April 8, 2024

RE: Lot 2 Elm Grove Villa - Smith Plumbing & Heating; Water Quality Detention Pond Certification

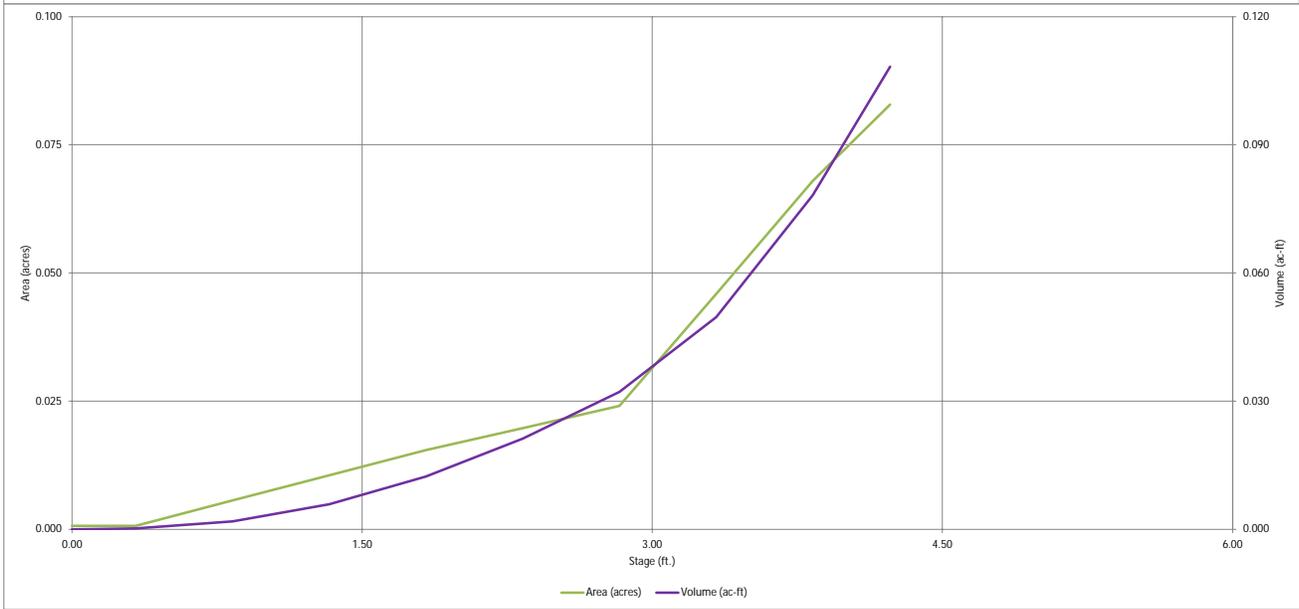
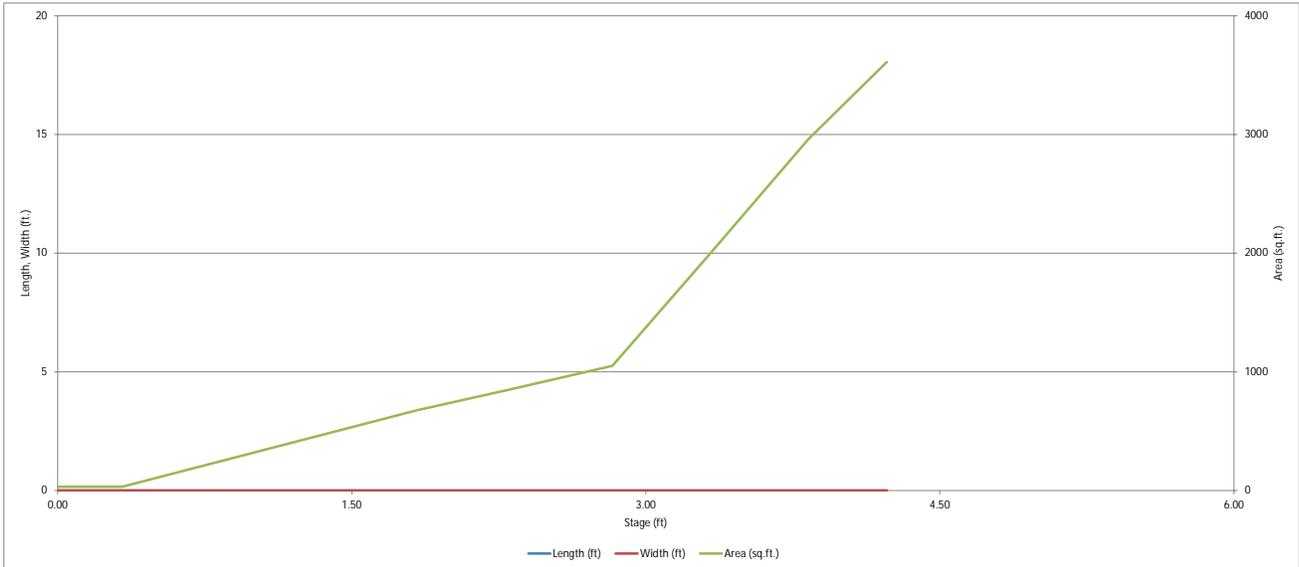
Revise/provide Pond Certification Letter with required statements listed in ECM Section 5.10.6.B: **REVISED**

### ORFICE PLATE DETAIL

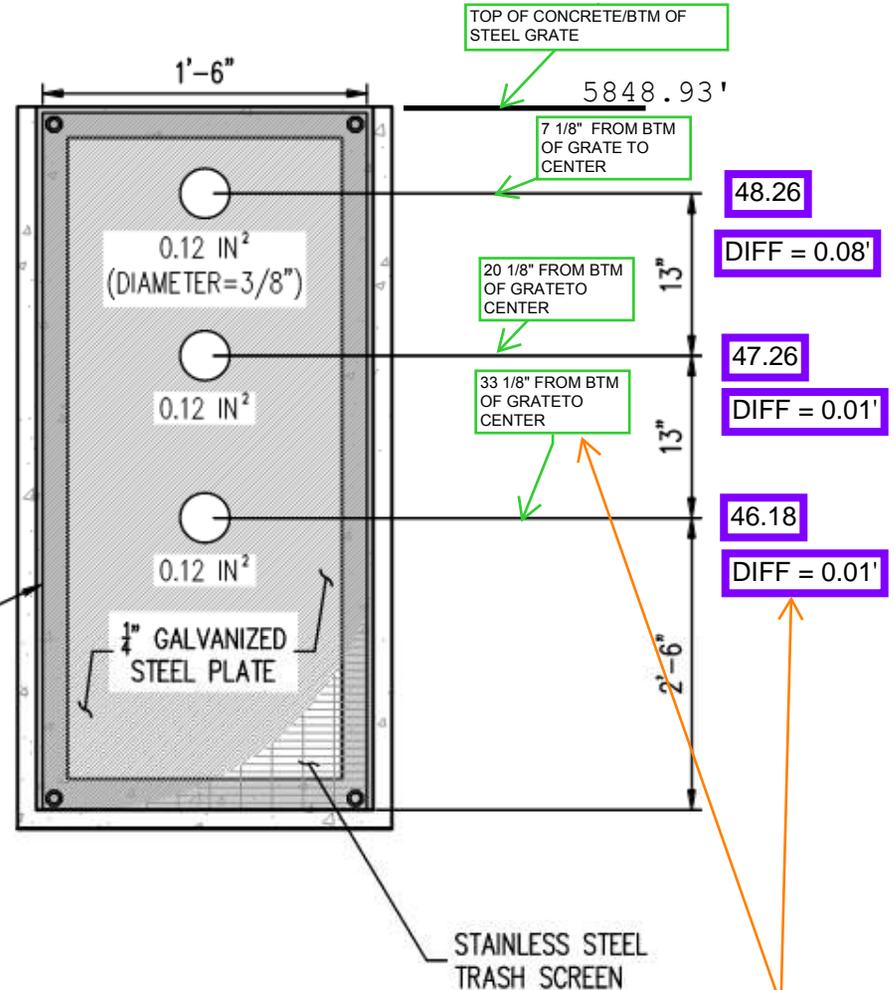
To avoid confusion, label the date that this survey data is from to clarify that the blue data is more recent - to show that the plate was modified since this red data was taken.

Or better yet, just delete all of this red data since it is not representative of the as-built condition.

Please copy all of these green and blue text boxes over to the detail on the previous page or overlay a screenshot of this page on top of the same detail on the previous page.

REVISED

REVISED AS THIS SHEET NO LONGER APPEARS IN THE AS-BUILT PLAN SET.
